# Office Action Summary

10/751,233

TUCKER, SEAN WILLIAM

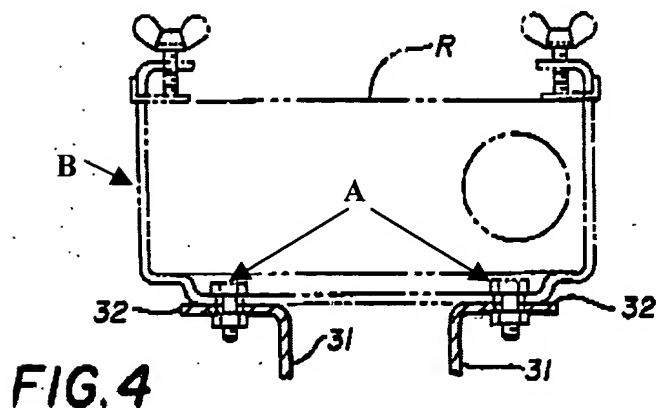
4. Claims 1-8 are rejected under 35 U.S.C. 102(b) as being anticipated by McIntyre (US 4,097,012).
  - a. Claim 1. McIntyre shows and discloses a fastening system comprising a first mount bracket 30 rotatably attached to a first assembly 11,20; a second mount bracket 30 (opposite side) rotatably attached to a second assembly 11,20,24; and a perpendicular rigid attachment A,B,R joining said first mount bracket 30 with said second mount bracket 30 wherein said attachment A,B,R enables said first mount bracket 30 and said second mount bracket 30 to rotate together about a common axis and wherein said attachment A,B,R enables a portion of said first mount bracket 30 and a portion of said

second mount bracket 30 to be separated by space (see figure 1 and annotated figure 4 below).

b. Claim 2. McIntyre further shows said first mount bracket 30 is attached to said first assembly 11,20 with an assembly screw 23a and an insert 33 (see figure 1 above).

- c. Claim 3. McIntyre further shows said insert **33** is a threaded insert and said assembly screw **23a** screws into said threaded insert **33** (see figure 1 above).

- g. Claim 7. McIntyre further shows rotatable fasteners **23a** for rotatably fastening the second leg **31** of one of said "L" brackets **30** to a structure **22** and for rotatably fastening the second leg **31** of the other "L" bracket **30** to a support **20,11** (see figure 1 above).

**FIG. 4**

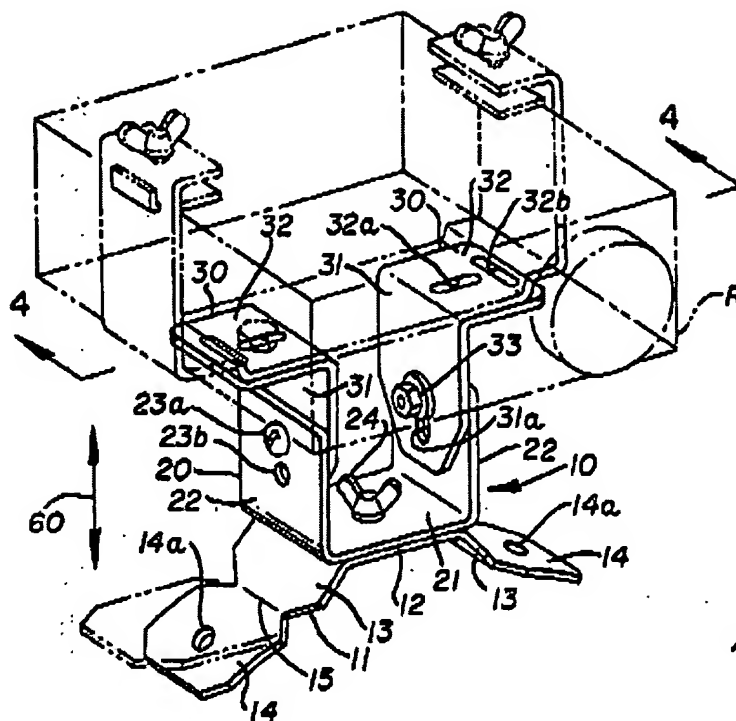
- d. Claim 4. McIntyre further shows said rigid attachment **A,B,R** between said first and second mount brackets **30** comprises a machine screw **A** (see annotated figure 4 above).

- e. Claim 5. McIntyre further shows said first mount bracket **30** further comprises at least one ear **32** for manual grasping and positioning of said fastening system (see figures above).

- f. Claim 6. McIntyre further shows said first and second mount brackets **30** each comprise a pair of "L" brackets, each of the "L" brackets having a first leg **32** and a second leg **31** and said rigid attachment **A,B,R** comprises fasteners **A** for removably joining together the first legs **32** of said "L" brackets, wherein the first legs **32** of said "L" brackets are separated by said space (see figures above).
